V2 submission. With additional clause 7.x.1a Fieldbus interconnection.

This is submitted as comments on the preCD 60802.

== Figure xx2 Factory Automation Network.

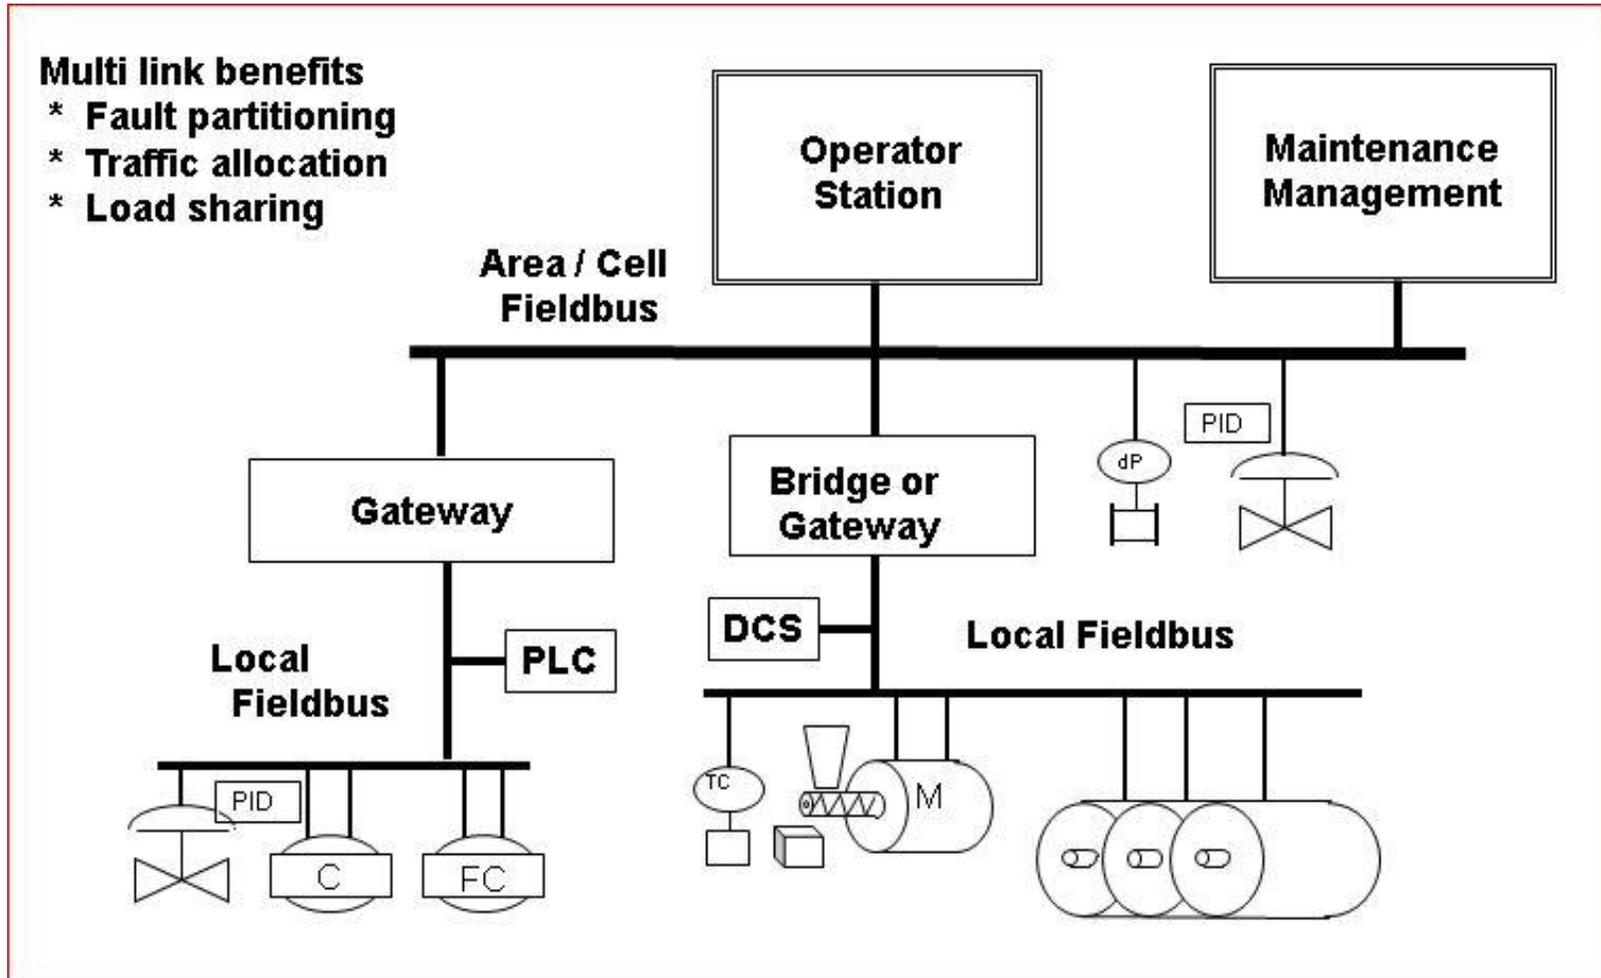
MB/NC ¹	Page number	Clause/Subclause	Par/Fig/Table/	Type	Comments	Proposed change	Observation secretariat
GW4		7.4		t	See comment gw2		
GW5	P49	7.5		t	Need to explain [and clarify with an example] how network management will configure a hierarchical network to achieve the basic process application hierarchy.	Please add a new clause and figures for the examples below.

Show the heirarchy Production line - Production cell - Machine unit
